UNITED STATES PATENT AND TRADEMARK OFFICE

APPLICATION NO.	FILING DATE	FIRST NAMED INVENTOR	ATTORNEY DOCKET NO.	CONFIRMATION NO.
10/538,943	06/13/2005	Tetsuya Komoguchi	09792909-6283	6002
26263 7590 01/28/2008 SONNENSCHN NATH & ROSENTHAL LLP P.O. BOX 061080 WACKER DRIVE STATION, SEARS TOWER CHICAGO, IL 60606-1080			EXAMINER TRAN, TAN N	
			ART UNIT 2826	PAPER NUMBER
			MAIL DATE 01/28/2008	DELIVERY MODE PAPER

Office Action Summary

DETAILED ACTION

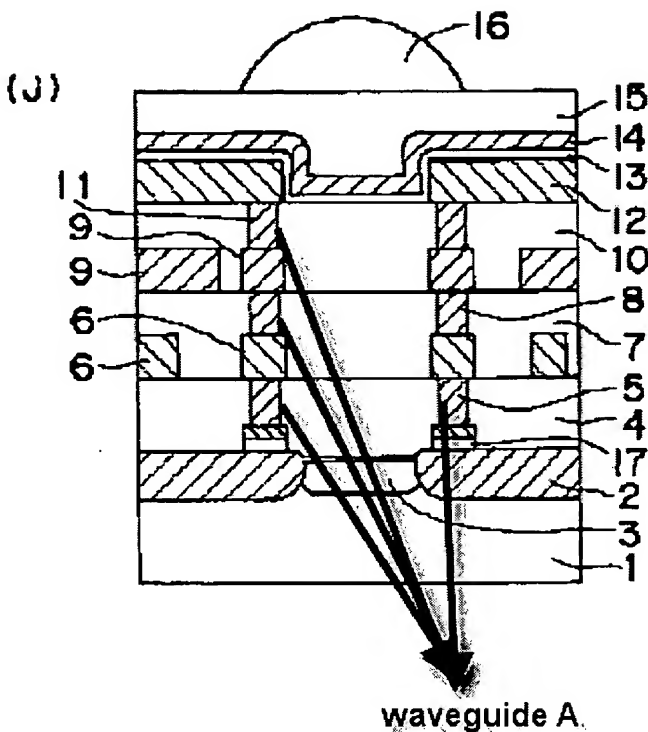
Claim 1 is rejected under 35 U.S.C. 102(b) as being anticipated by Kawasaki (JP-2001-267544).

With regard to claim 1, Kawasaki discloses a plurality of light-receiving sections 3 (it is inherent that Kawasaki disclose a plurality of light-receiving sections in order to provide array of solid-state image pickup device formed on the same substrate) and which generate charge in response to incident light (because sections 3 are the light-receiving sections); a insulating layer 4 functioning as a planarizing layer which covers predetermined elements 15 disposed on the substrate 1 to perform planarization [paragraph 0033, lines 10-13]; a plurality of signal lines (6,9) disposed above the planarizing layer (layer 4); a waveguide (A as shown in the attached fig.) which guides incident light to each of the light-receiving sections 3 (see fig. 1A, and attached fig.), the waveguide (A as shown in the attached fig.) passing through the space between the plurality of signal lines (6,9). (Note see attached fig. and figs. 1A, 9J of Kawasaki).

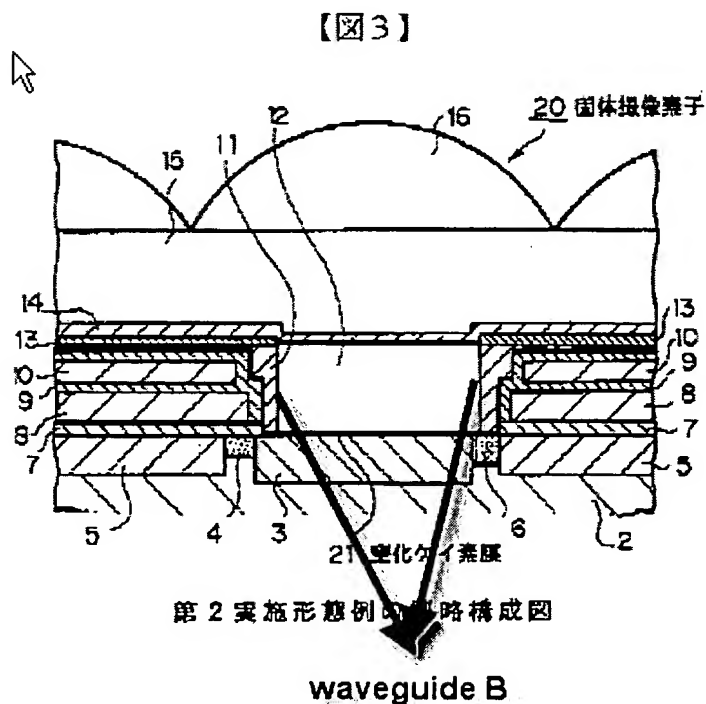
Claims 19-23 are rejected under 35 U.S.C. 103(a) as being unpatentable over Kawasaki (JP-2001-267544) in view of Fukusho (JP-10-326885).

With regard to claims 19,20, Kawasaki is silent that the waveguide comprises a light-transmissive film having a relatively high refractive index, the light-transmissive film being embedded in a hole formed by an insulating film having a relatively low refractive index, the

However, Fukusho discloses the waveguide (B as shown in the attached fig) comprises a light-transmissive film (transparent film 12) having a relatively high refractive index (lines 7-12 of Abstract in the translation), the light-transmissive film (transparent film 12) being embedded in a hole formed by an insulating film 11 having a relatively low refractive index (lines 7-12 of Abstract in the translation), the light-transmissive film (transparent film 12) includes a first material portion containing at least hydrogen wherein the first material portion comprise silicon nitride (lines 11,12, paragraph 0022, fig. 3 of Fukusho). (Note see attached fig. and fig. 3 of Fukusho).

Therefore, it would have been obvious to one of ordinary skill in the art at the time of the claimed invention to include the waveguide comprises a light-transmissive film having a relatively high refractive index, the light-transmissive film being embedded in a hole formed by an insulating film having a relatively low refractive index, the light-transmissive film includes a first material portion containing at least hydrogen wherein the first material portion comprise silicon nitride in Kawasaki's device, as taught by Fukusho, motivated to carries out total reflection between insulating layer and transparent film.

With regard to claims 21-23, Kawasaki is silent that an etching stopper film for forming the hole is provided on the upper surface of a gate-insulating film on the light-receiving section, the first material portion is in contact with the gate-insulating film through an opening of the etching stopper film; Wherein the etching stopper film comprise silicon nitride formed by low-pressure CVD and at least the etching stopper film extends to above transistor region provide in the substrate in the periphery of the light-receiving section.

However, Fukusho discloses an etching stopper film 21 for forming the hole is provided on the upper surface of a gate-insulating film 7 on the light-receiving section 3, the first material portion is in contact with the gate-insulating film 7 through an opening (where transparent material 12 forming in the etching stopper film 21) of the etching stopper film 21; Wherein the etching stopper film 21 comprise silicon nitride formed by low-pressure CVD (lines 6,7, paragraph 0023) and at least the etching stopper film 21 extends to above transistor region 5 provide in the substrate 2 in the periphery of the light-receiving section 3. (Note see attached fig. and fig. 3 of Fukusho).
